**ADDENDUM NO. 2
MAY 13, 2019**

BID # 2248-19 FIRE ALARM RENOVATIONS (EASTERN MIDDLE SCHOOL)

This Addendum No. 2 is being issued to state the following regarding the Mandatory Pre-Bid walk through on Wednesday, May 8, 2019 at 1:00PM

EASTERN MIDDLE SCHOOL – AOR RISER DIAGRAM

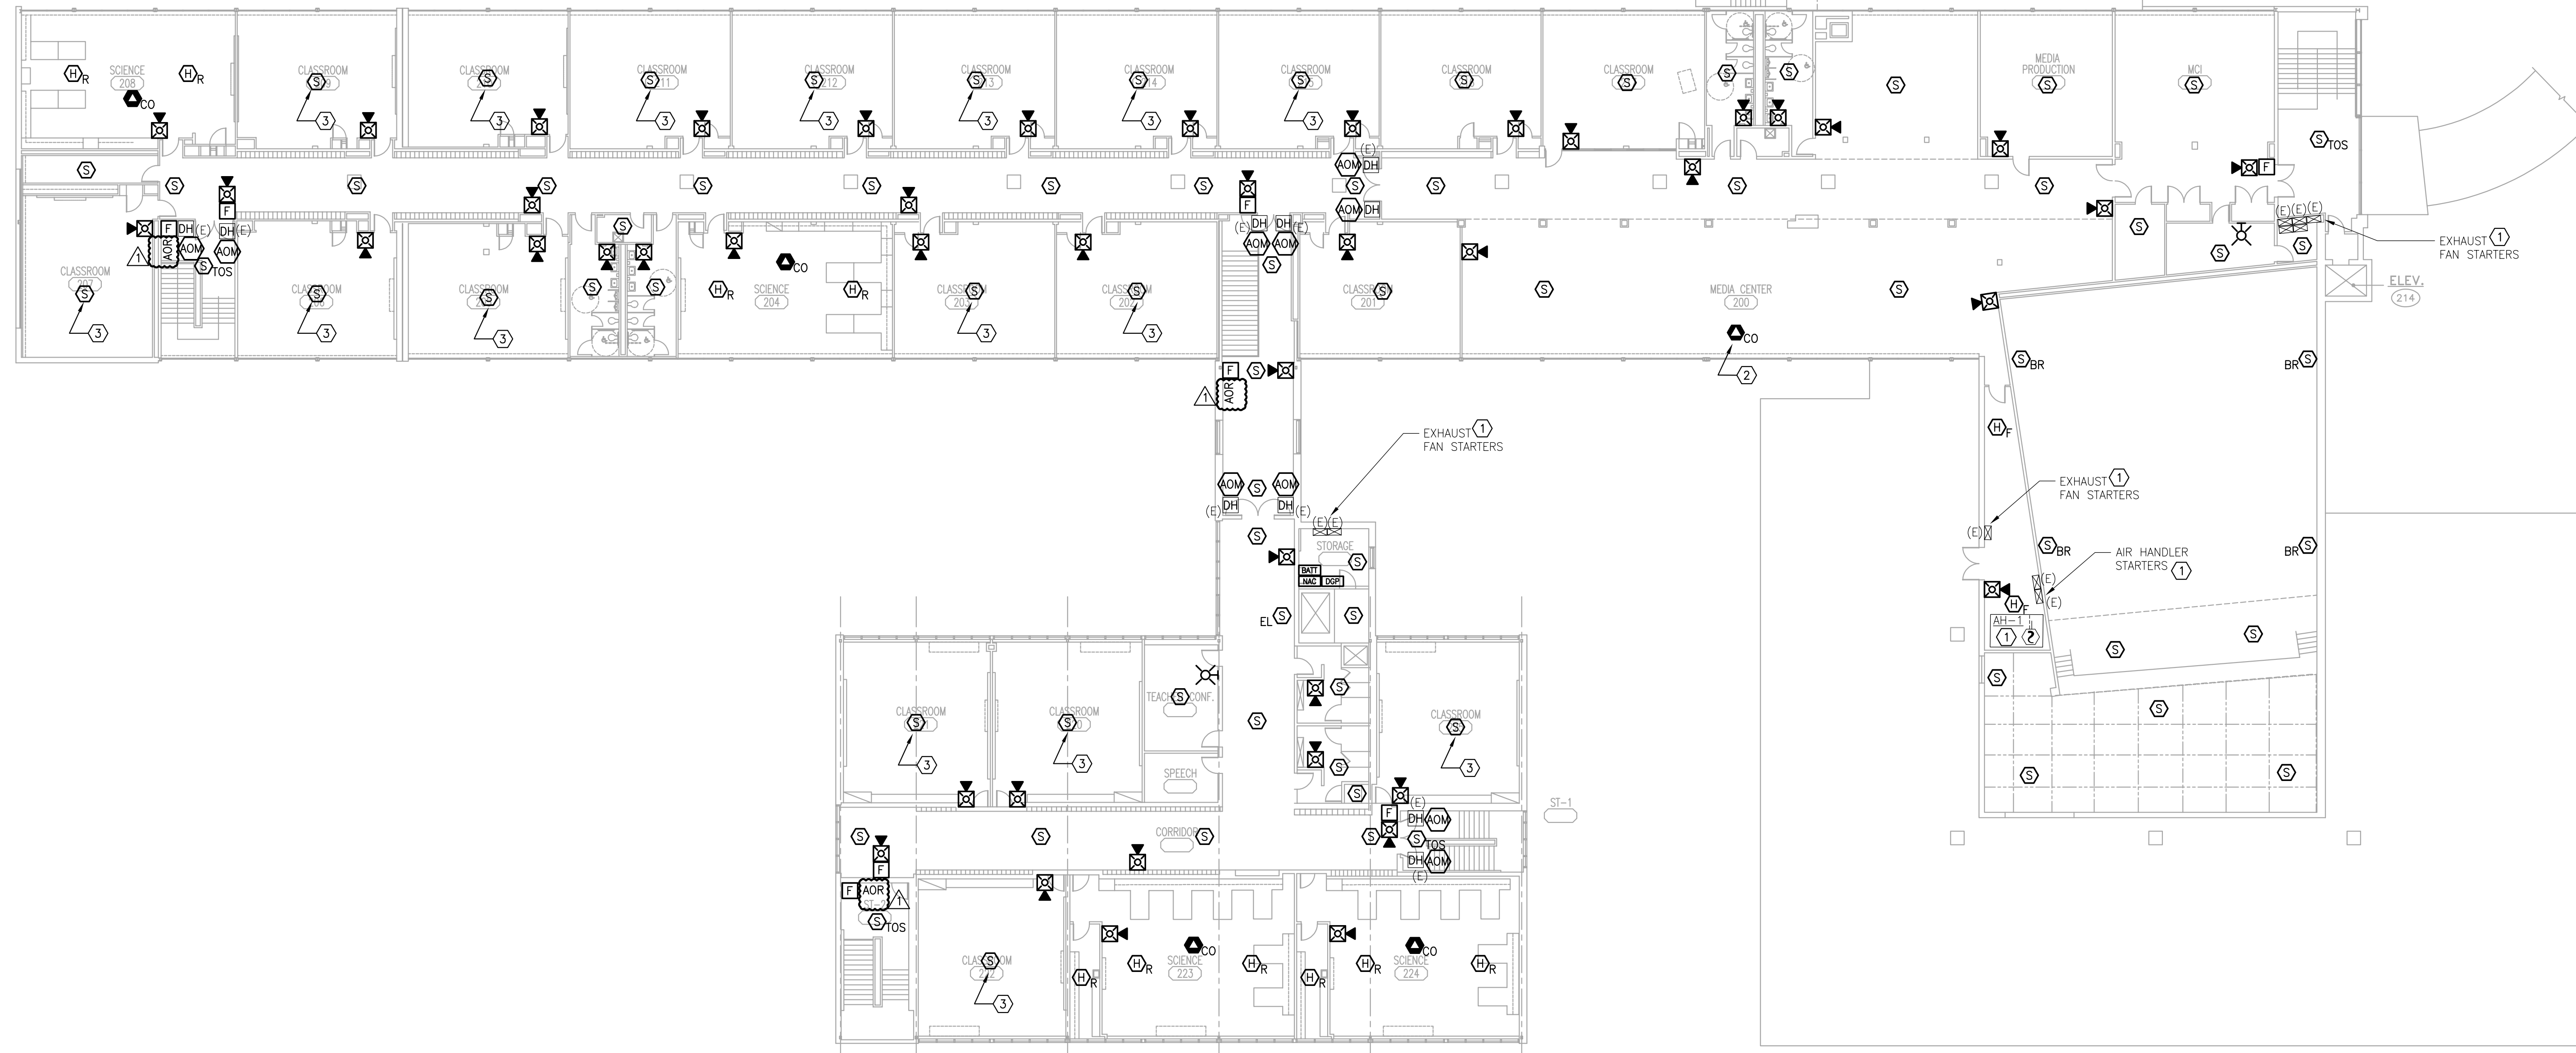
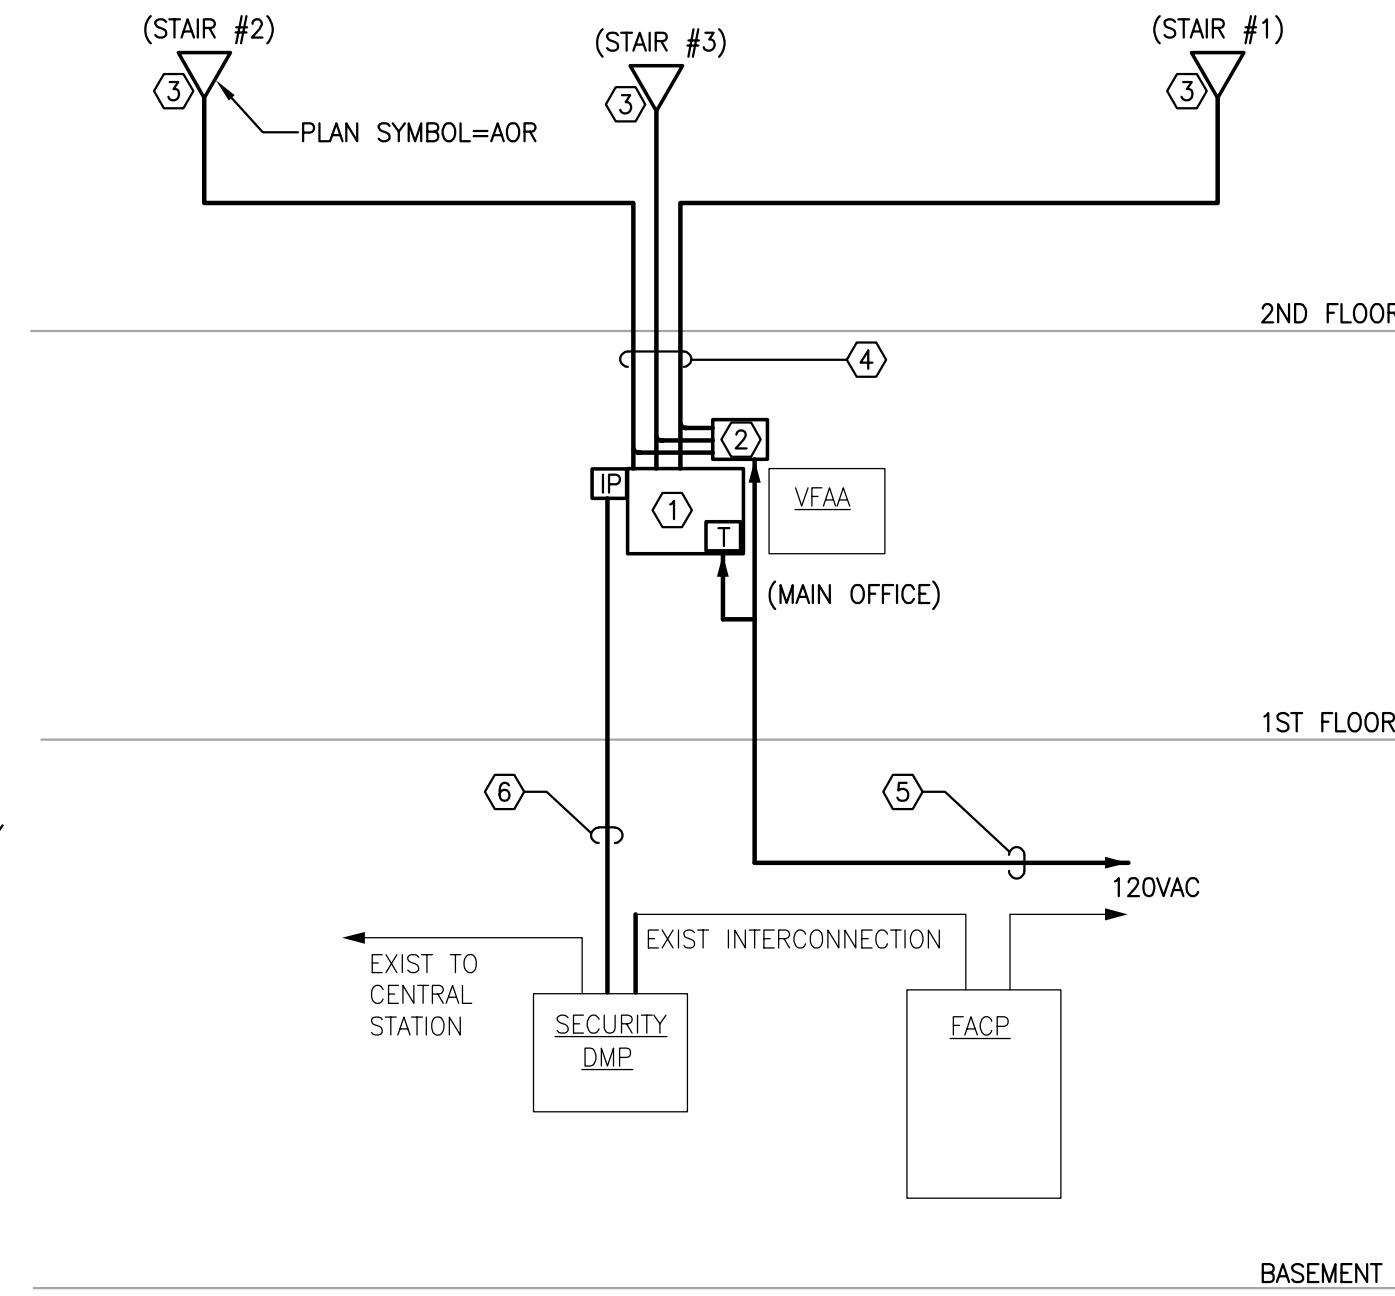
- (3) Area Of Refuge (AOR) panels were added to project scope. Refer to attached drawing FA-201, revised 5/13/19 for additional information.

AOR SEQUENCE OF OPERATIONS

INITIATION OF AN AREA CALL STATION WILL ACTIVATE AUDIO AND VISUAL SIGNAL IN MASTER AOR PANEL.

MAIN OFFICE ACKNOWLEDGES CALL BY LIFTING PHONE AT AOR MASTER FOR 2-WAY COMMUNICATIONS.

IN EVENT STAFF UNAVAILABLE, AOR PROGRAMMED FOR OFF SITE SERVICES BY CENTRAL STATION TO RESPOND SAME AS WOULD FOR FIRE ALARM SYSTEM.

PROPOSED SYSTEM TO BE BY HOUSING DEVICES INC OF THE ADA-ARCU-5 SERIES WITH MASTER PANEL, AREA PUSHBUTTON STATIONS, ALL REQUIRED POWER SUPPLIES, INTERCONNECT MODULES FOR OFF SITE SERVICES, AND REQUIRED ACCESSORIES FOR INSTALL TO INCLUDE AREA PHONE BOX/PLATE MODIFICATIONS AS NEEDED

SYSTEM VENDOR TO PROVIDE WIRING DIAGRAM, ASSIST WITH PROGRAMMING TO SUIT SCHOOL NEEDS, AND INCLUDE STANDARD WARRANTY ON PARTS AND SERVICE.

1. MASTER AOR PANEL LOCATED ADJACENT TO NEW VOICE FIRE ALARM ANNUNCIATOR IN MAIN OFFICE. MASTER AOR PANEL TO HAVE INTEGRAL BATTERY SUPPLY OF STANDARD SIZE /TYPE BY AOR MANUFACTURER. PROVIDE AT PANEL A REMOTE TRANSFORMER AND ADDRESSABLE MODULE/GATEWAY FOR CONNECTION TO SAME DMP SERVING FIRE ALARM.
2. REMOTE POWER SUPPLY LOCATED AT MASTER PANEL FOR 24VDC TO AREA CALL STATIONS.
3. AREA CALL STATION TO REPLACE EXIST AND FITTED TO BACKBOX WITH NEEDED PLATE.
4. COMMUNICATION CABLE AND POWER CABLE PER MANUFACTURER TO AREA CALL STATIONS.
5. CONNECTION TO 120V-20A/1P BREAKER IN EXIST ALTERNATE SOURCE PANEL IN BASEMENT.
6. CONNECTION TO EXIST SECURITY SYSTEM DIGITAL MONITORING PANEL FOR OFF SITE SERVICES.
